### **SUBMISSION OF THE TECHNICAL RULES PRELIMINARY REPORT**

**Technical Rules Committee  
Preliminary Report**

**December 2005**

**Figure 3.1 Synchronous Generating Unit Reactive Power Capability Requirements at Generator Terminals shown Shaded**

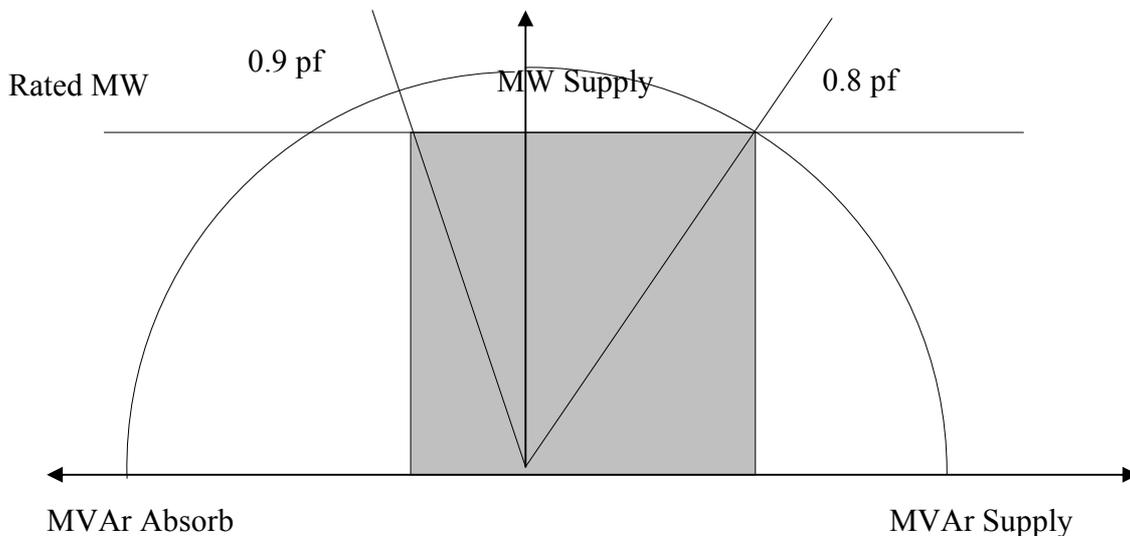
The member noted that within other sections of the rules Users must provide a load with power factors in the range of >0.95 lagging and suggested that Western Power should respecify the power factor performance range to 0.9 lag to 0.9 lead.

**Figure 3.4 – Off Nominal Frequency Operation Capability Requirement for Generators**

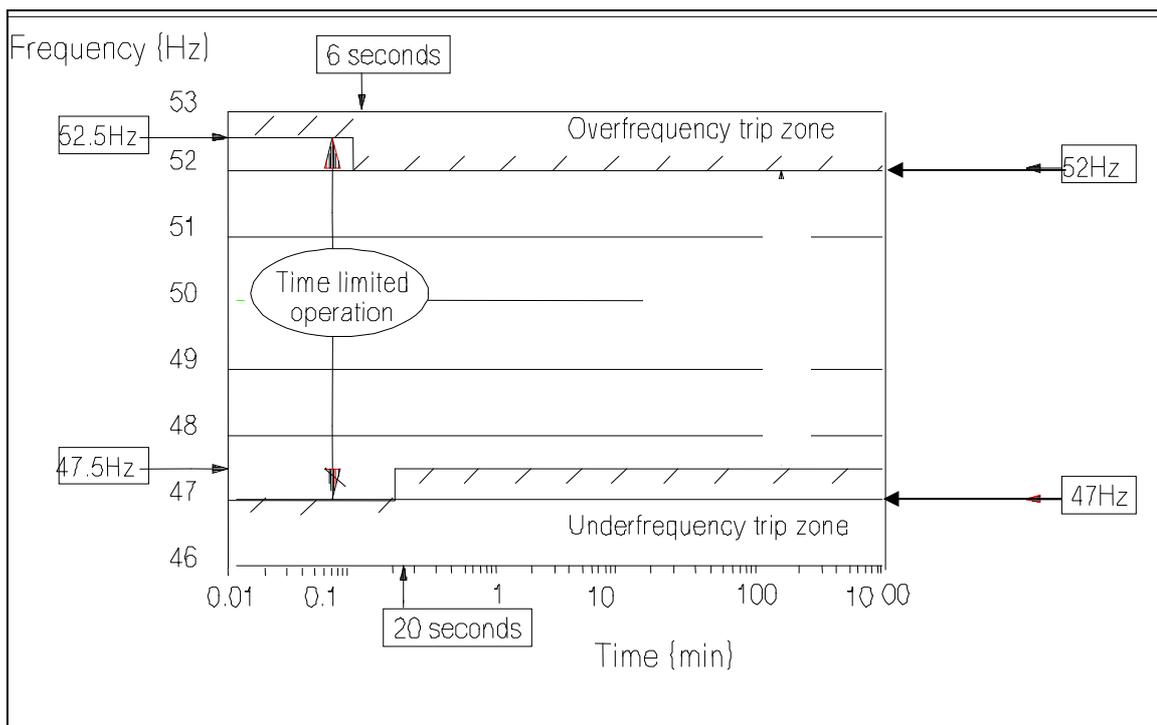
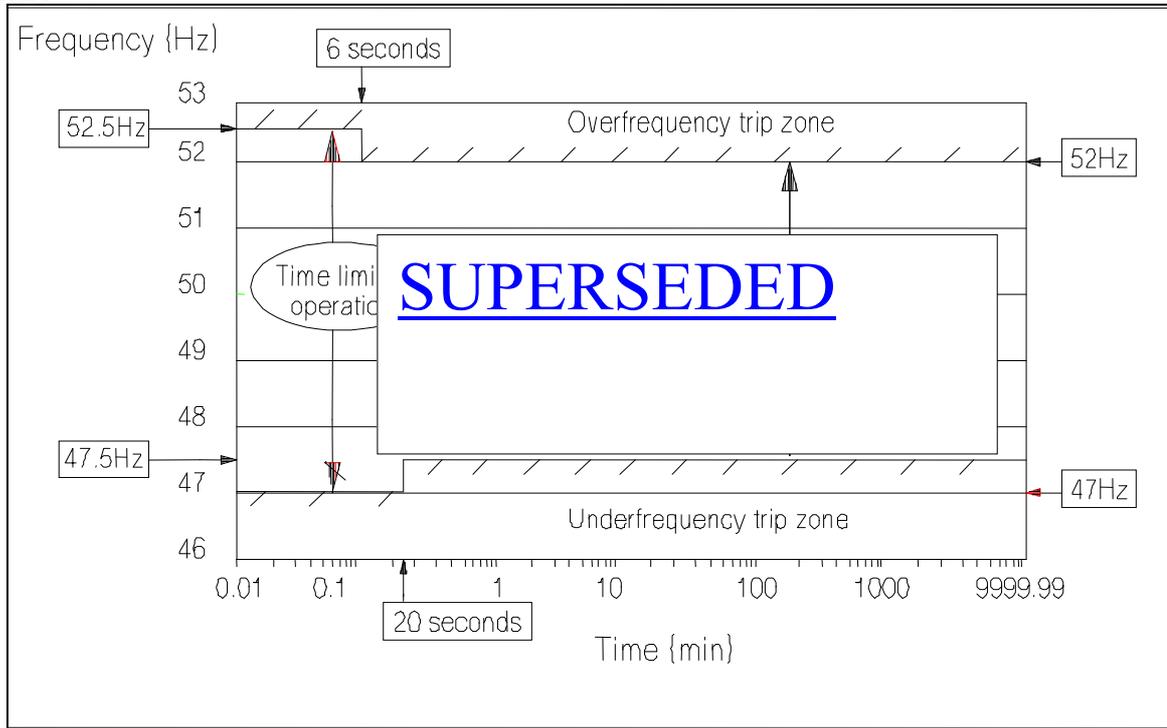
- In section 3.2.4.3(a) , the requirement for Users to ensure generating equipment capable of remaining in service for frequency limits as in Figure 3.4 is onerous for particular machines. The User gave the example that steam turbines and gas turbines typically have UF thresholds set by OEM’s at 47.5Hz or higher so are incapable of continuous operation at that level.

In relation to part c), Western Power has indicated their disagreement with the User's concern. Western Power's response is that there are steam, gas, and combined cycle power stations in the SWIS which comply with 3.2.4.3(a).

**Figure 3.5 – Off Nominal Voltage Operation Capability Requirement for Generators that complement those of Figure 2.1**

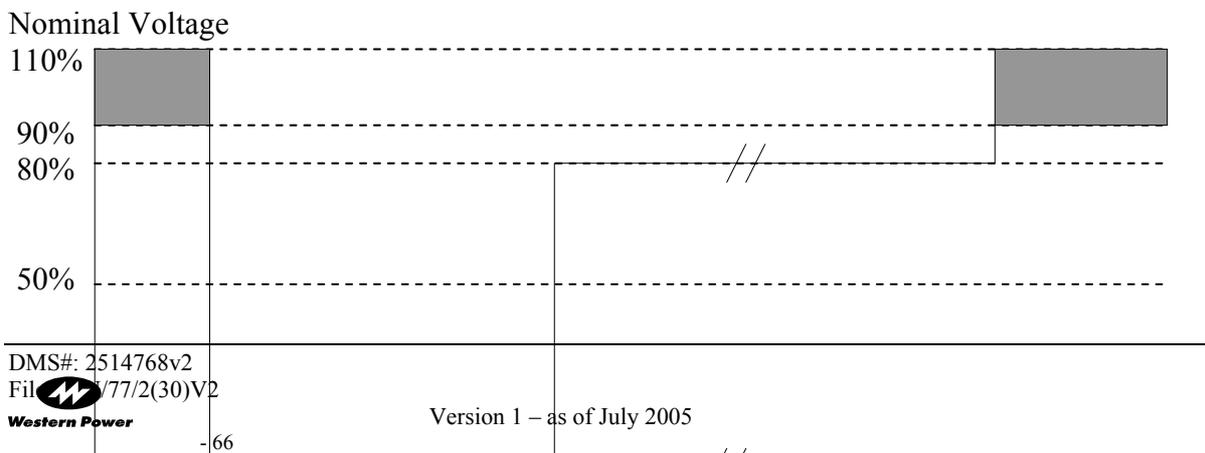
- d) In section 3.2.4.3 (b) Voltage Excursions – Users to ensure generating unit capable of continuous uninterrupted operation even while the voltage at the connection point is between 0-80% for 450ms (as opposed to the National Electricity Code standard of 175ms due to their faster clearance times) or up to 110% for 10 secs is too onerous;
- e) The requirement in section 3.2.4.3(c) for generators to be capable of uninterrupted operations at 4 Hz/sec is too onerous and should be replaced with an UFLS scheme to prevent such a high rate of change of frequency; and
- f) The terms “leading” and “lagging” have different meanings from generator and network perspectives. These should be replaced with “absorb” and “supply”.

In relation to part b), Western Power amended the section by deleting reference to continuous operation in Figure 3.5 and reducing the time interval to 1000 minutes (from 9999 minutes).

Figure 3.4 – Off Nominal Frequency Operation Capability Requirement for Generators-

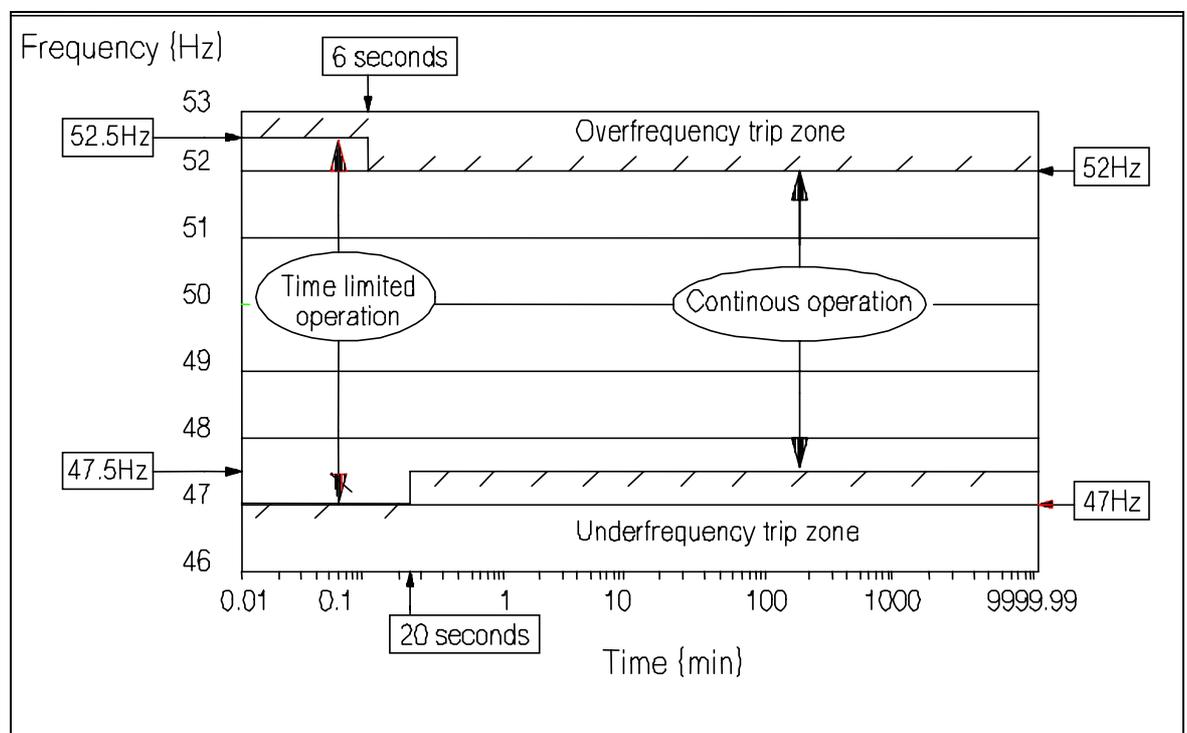
The use of the phrase “continuous operation” in Figure 3.4 (see Appendix A) is not quite right because the time scale of Figure 3.4 is limited to 10,000 minutes or just under 7 days.

Clarifications “time limited operation” and “continuous operation” in Figure 3.4 stem from the UK Grid code terminology (their requirements are verbally formulated and there is no time limit for the operation in the frequency range between 47.5 and 52 Hz).

The margin between the target system performance of Table 2.1 and design plant immunity of Figure 3.4 is a safety margin designed to ensure that the generating plant is tripped only when it is essential for system reasons (for example when a stability limit is reached).

**Figure 3.5 – Voltage variation during voltage dip**  
Comparison of old (solid black line) and new (green line) requirements and rationale.

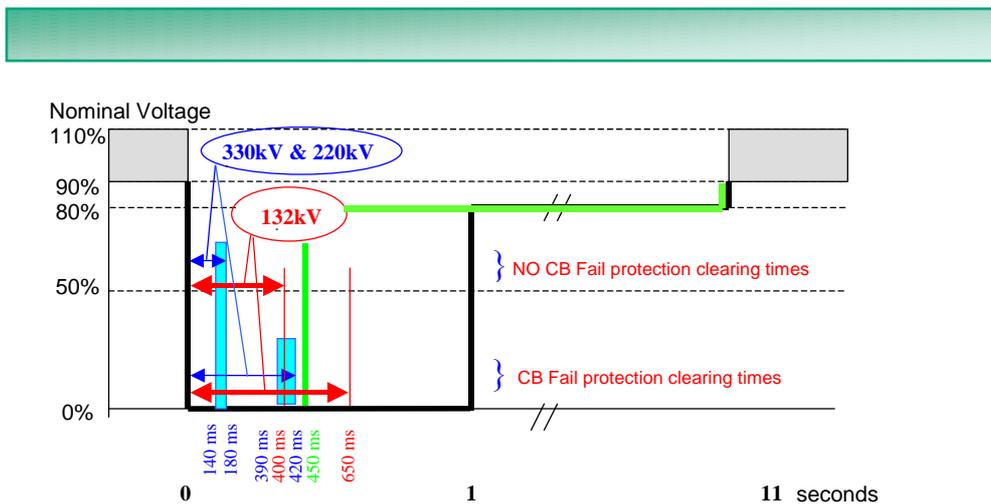
The proposed fault ride through capability requirement is not representative of typical system conditions during a disturbance but is a generator performance requirement. It is also not proposed that individual generators be subject to testing for this capability. Nevertheless proponents would be required to demonstrate that generator auxiliary systems are capable of surviving such voltage excursions without stalling or disconnecting. It is expected that this would be less of an issue for gas turbine plant than coal fired power stations.
